ASSESSMENT REPORT

Central Park Concept Approval (MP 06_0171 MOD 12) and Block 4N – Mixed Use Development (SSD 6673 MOD 1)

Figure 3: Approved Public Domain Plan

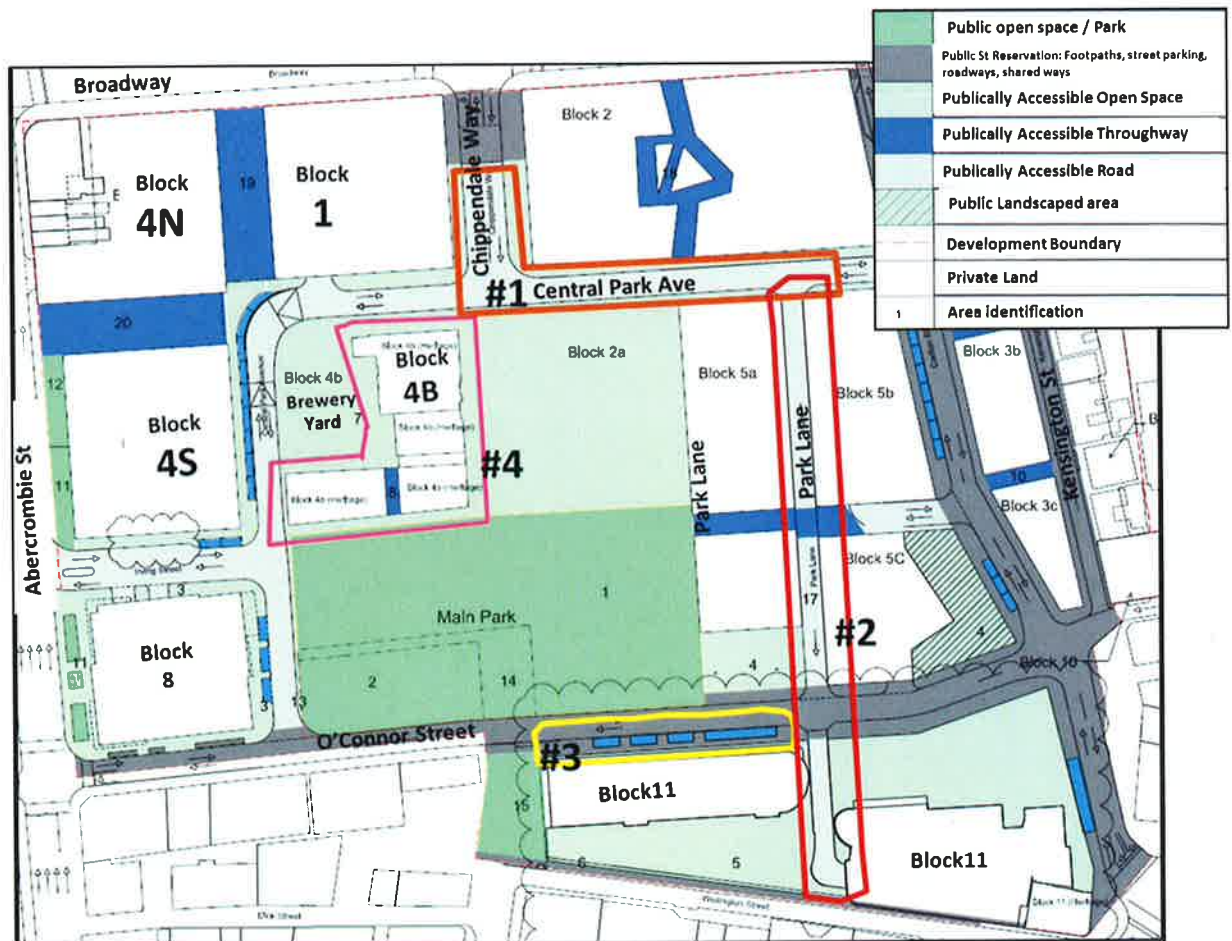
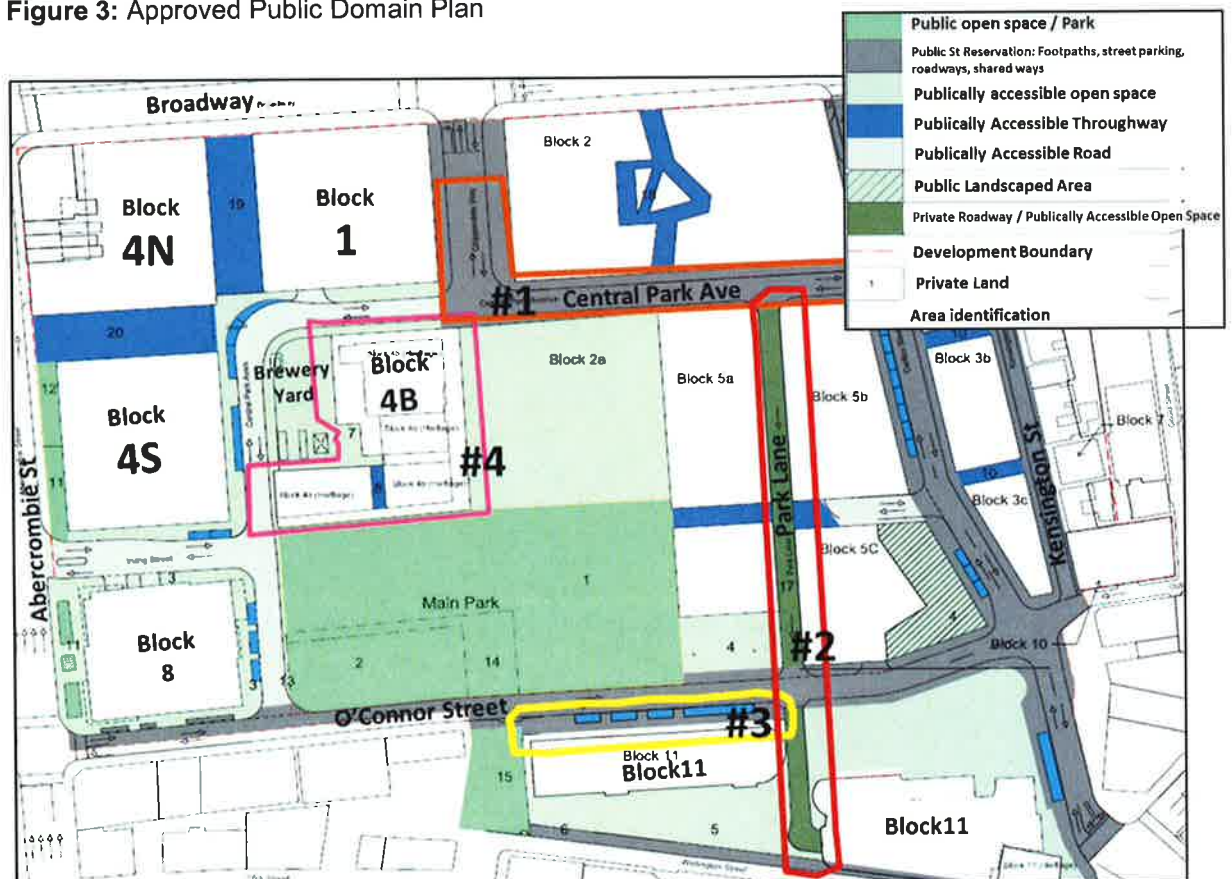
Park Lane and the access driveway to Block 11 (see **Figure 3 and 4**) is proposed to be retained in private ownership, and converted from a publically accessible 'street' to a private driveway that is publically accessible for pedestrians. Council raised no objection to this modification but notes that appropriate easements to ensure public access will be required. The Proponent has confirmed easements for public access will be implemented in each relevant project or development approval.

The modification seeks to amend the setback around the Block 4B brewery buildings (See area identified a No.4 in **Figures 3 and 4**). Currently the area up to the building line is identified as publically accessible open space. The Proponent seeks approval for part of the area around the building to be made private land.

The Department considers converting Park Lane from a publically accessible 'street' to a private driveway, that is publically accessible for pedestrians, is acceptable as the development would continue to provide sufficient vehicular access throughout the Central Park site. The Department also notes the Concept Plan approval includes a condition (Condition B4) which requires Rights of Way and Easements on title to ensure public access is provided and maintained.

The Department considers the proposed reduction in publically accessible land around Block 4B is a minor change and would not result in any material adverse impact, noting:

Figure 5: Approved and Proposed layout of outdoor terrace at the Broadway frontage.

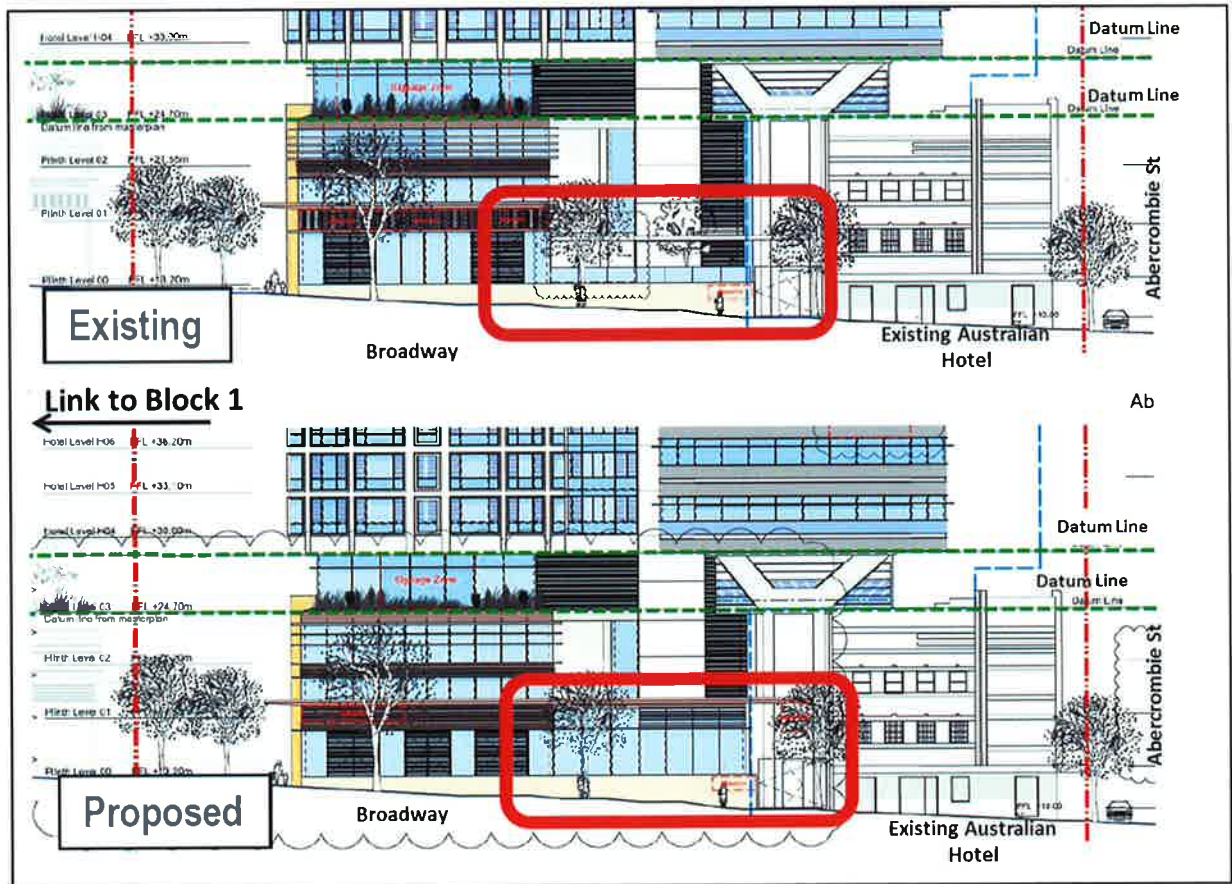
- The enclosure of the outdoor terrace at the Broadway frontage and changes to landscaping are not supported for reasons relating to: outdoor amenity; street activation; visual impacts and heritage impacts;
- Council does not support the additional signage zones on the north and west elevation;
- Consideration should be given to the impact of the internal changes to the communal hotel facilities on the amenity of the hotel; and
- Clarification was sought regarding the roof design changes and if changes were proposed to the residential section of the development.

Following the submission of the RTS Council advised that while a number of its issues had been addressed, its concerns relating to the enclosure of the terrace, landscaping changes, and hotel amenity have not been satisfactorily addressed.

Issue	Consideration	Recommendation
<i>Consistency with Concept Approval</i>	<ul style="list-style-type: none"> • The proposed modifications to Block 4N are minor and do not alter compliance with the key requirements of the Concept Approval in terms of: <ul style="list-style-type: none"> ○ maximum GFA; ○ design excellence; ○ site servicing; ○ parking rates; ○ provision of public benefits; or ○ sustainable design. • The Concept Approval also sets out requirements for street activation and heritage preservation. These issues are discussed in further detail below and it is considered the proposed modifications do not result in any unacceptable impacts in terms of activation or heritage. • The Department is therefore satisfied the proposal, as modified would remain consistent with the Central Park Concept Plan approval. 	No additional conditions or amendments necessary.
<i>Enclosure of Outdoor Terrace</i>	<ul style="list-style-type: none"> • The proposal seeks to enclose the outdoor restaurant and remove the landscaping and water feature from the ground floor of Block 4N fronting Broadway. • The Proponent advised the proposed change is sought to meet the amenity needs of the hotel and to respond to the context of the site facing Broadway. • Council does not support this aspect of the modification as it would result in: <ul style="list-style-type: none"> ○ reduced street activation; ○ loss of visual connection to the interior of the site; ○ loss of a sense of open space between the development and the heritage listed Australian Hotel; and ○ deletion of a canopy tree and loss of visual relief from the water feature. • With regard to street activation, the Department acknowledges the approved terrace is unlikely to be highly utilised, due to its exposure to high traffic volumes along Broadway. The activation of this space is already comprised as the outdoor terrace cannot be directly accessed from Broadway. • Given these site constraints, the Department is satisfied the proposed enclosure of the terrace would not result in a significant loss or change to the activation of this part of the site. • With regard to the loss of visual connection into the site, the Department considers the void between Block 4N and the Australian Hotel would not be significantly impacted by the enclosure of the terrace as it is a single storey addition and the majority of the void space above the terrace would be retained. 	The Department recommends a new condition requiring amended plans of the Broadway Street elevation. .

<i>Issue</i>	<i>Consideration</i>	<i>Recommendation</i>
	<p>The Department also notes the enclosure would be constructed of glazing providing a light weight transparent structure, reducing its visual impact.</p> <ul style="list-style-type: none"> • With regard to landscaping, the Department considers the proposed changes are minor and the proposal would still provide appropriate hard and soft landscaping to this part of the site. • The loss of the water feature from the Broadway frontage would expose a large expanse of blank wall to the street, reducing the design quality of this part of the development. Maintaining an appropriate level of design along Broadway is important as it is a key pedestrian thoroughfare into the southern part of the city. In addition, ensuring the development achieves design excellence was a key requirement of the Concept Plan approval. The Department has therefore included a new condition requiring amended plans to be submitted to demonstrate that an appropriate design is achieved for this elevation. • Overall, the Department is satisfied the enclosure of the terrace is acceptable and would not have a significant impact on street activation or any unacceptable visual impacts, subject to conditions.

Figure 11: Approved and proposed site throughway

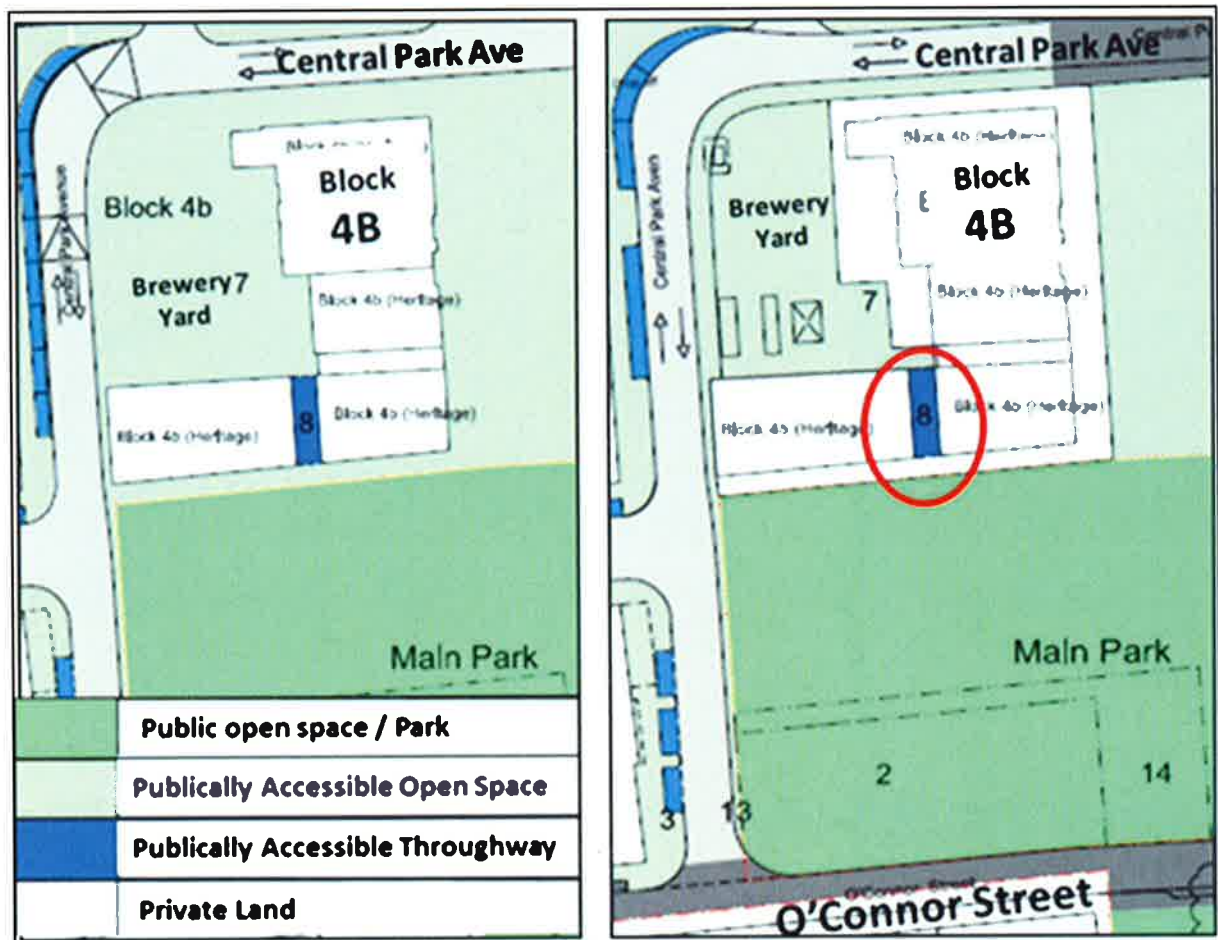
The Department also notes that the public domain plan requires the provision of a publically accessible through site link (see **Figure 11**). This link needs to be extended through the proposed 'private' southern curtilage (see highlighted in red below) to ensure it can operate effectively as a publically accessible thoroughway. A condition is therefore recommended requiring an updated public domain plan which illustrates the publically accessible thoroughway fully connects to the main park and not to privately owned land.
